I enjoyed reading the manuscript “Influence of groundwater recharge projections on climate-driven subsurface warming: insights from numerical modeling.” The manuscript presents a clear objective, employs a sound methodology to achieve it, and reports results that are well presented and supported by the discussion and conclusions. Most of my comments focus on improving clarity in certain sections.

We would like to thank reviewer#2 for their positive feedback on our study, as well as for the in-depth review and constructive suggestions. In what follows, we provide our point-by-point responses to each comment (our answers are marked in red).

Figure 1: Performance weights for 15 GCMs resulting from the ClimWIP procedure based on the preselected evaluation criteria for the historical period (modified after Nguyen et al., 2024). 7 GCMs selected for the current study are marked in red.

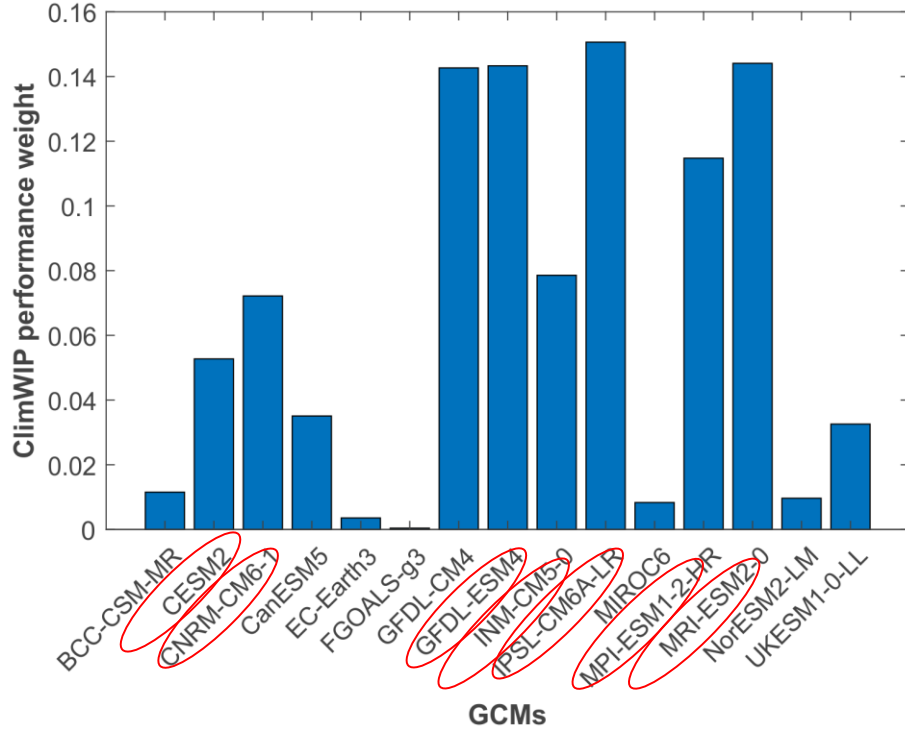
Line 167: Could you please explain why these seven GCMs were selected? Since many GCMs are available, I am curious whether these models have specific characteristics that make them particularly suitable for this study. Clarifying this would also address the question of why seven—why not five, ten, or the full ensemble?

Thank you for this helpful comment. The selection of the seven GCMs in our study follows the same strategy used in Nguyen et al. (2024), where models were chosen based on a combination of performance- and independence-based criteria. In that work, GCMs were evaluated using the ClimWIP (Climate model Weighting by Independence and Performance) method (Brunner et al., 2020) as implemented in ESMValTool v2.6.0 (Eyring et al., 2016). The selection relied on quantitative metrics—specifically each model’s distance to ERA5 over Europe for 1985–2014 temperature and sea-level pressure climatology, annual variability, and temperature trends—as well as qualitative considerations of model independence and spread following the recommendations of Merrifield et al. (2023). This approach identifies a subset of CMIP6 models that provides a representative range of climate responses while avoiding unnecessary inter-dependencies between closely related models and reducing the computational load for both the weather generator and subsequent impact modeling.

We will clarify this briefly in the updated manuscript.

Figure 2: River network of the study area (LfU, 2023) and the model boundaries.

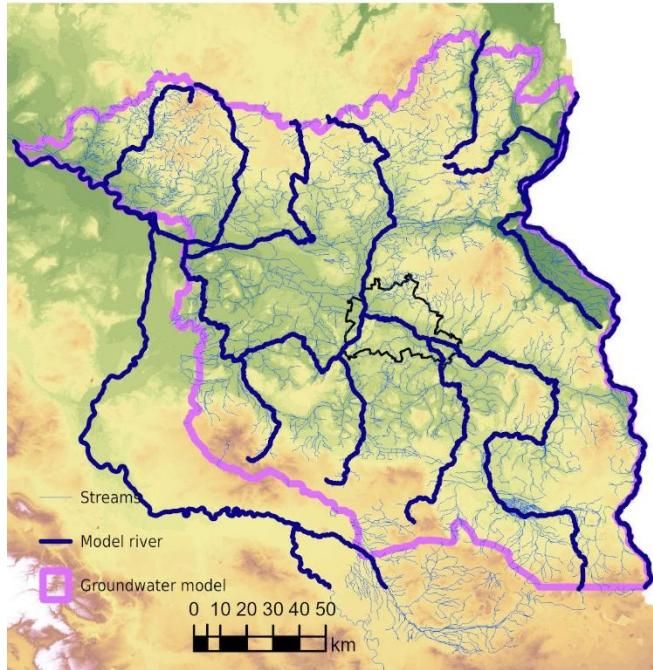
Line 227: What proportion (in percentage) of the model's lateral boundaries coincide with rivers?

The proportion of the river boundaries is approximately 50% (basically eastern and northwestern edges corresponding to Oder and Elbe rivers respectively). In the revised manuscript we will replace the phrase “At lateral model edges a constant-head Type I (Dirichlet) boundary condition (BC) was assigned, given that they largely correspond to major rivers” with a more quantitative statement.

Figure 3: Steady-state groundwater model calibration results: simulated versus observed hydraulic head and temperature at monitoring points (locations shown in Figure 1c). RMSE – Root Mean Square Error, nRMSE – normalized to value range; R^2 – coefficient of determination; σ – standard deviation.

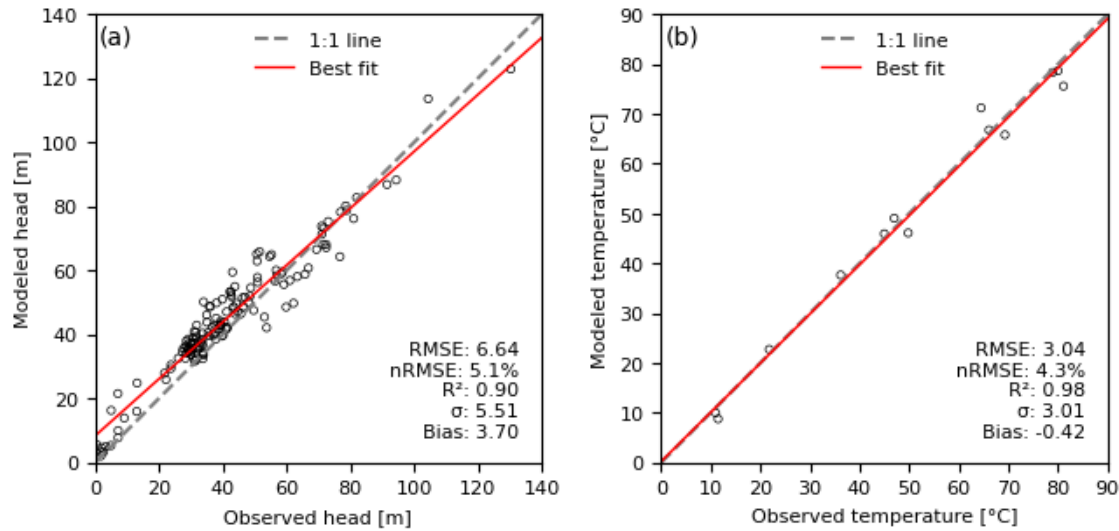
Some darker points appear in Figure 5a. Do these points represent a specific subset of observations, or are they a rendering artifact? Additionally, could you add a measure of bias between modeled and observed heads and temperatures?

Yes, this is an artefact of the overlapping points. The bias for heads was 3.70, and for temperature it was -0.42. We thank reviewer#2 for these suggestions. The new version of the plot reflects these changes (Figure 3).

Figure 4: Schematic cross-section, illustrating patterns of groundwater flow and the thermal field for different surface and geological domains.

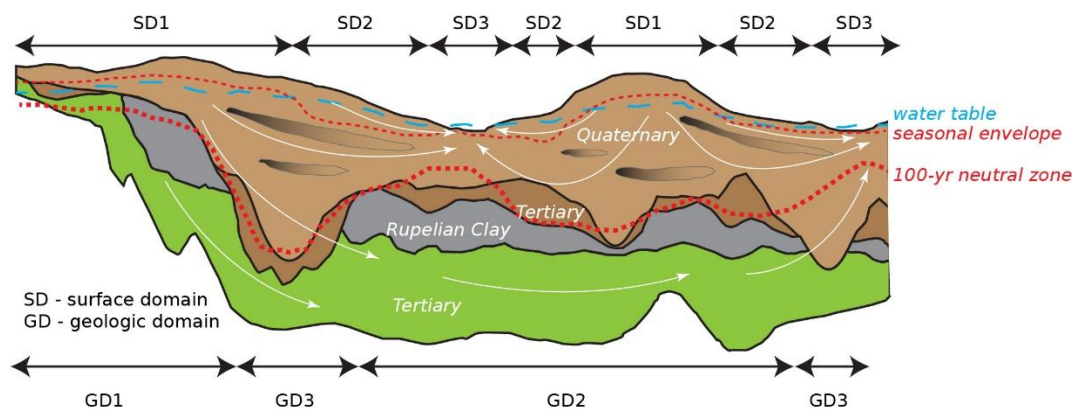
Section 6.1 is clearly written, and Figure 13 is well designed. However, I'm a bit confused: GD3 is described as an area where "the Rupelian is locally eroded, allowing direct hydraulic connection between Quaternary

aquifers and deeper formations”. In Figure 13, the region labeled GD3 appears to still contain Rupelian clay (gray unit), which does not reflect such a direct connection. Could you clarify this?

We thank reviewer#2 for pointing on this inconsistency. GD2 and GD3 labels must be swapped in the schematic (Figure 4) to be consistent with the description in the text.
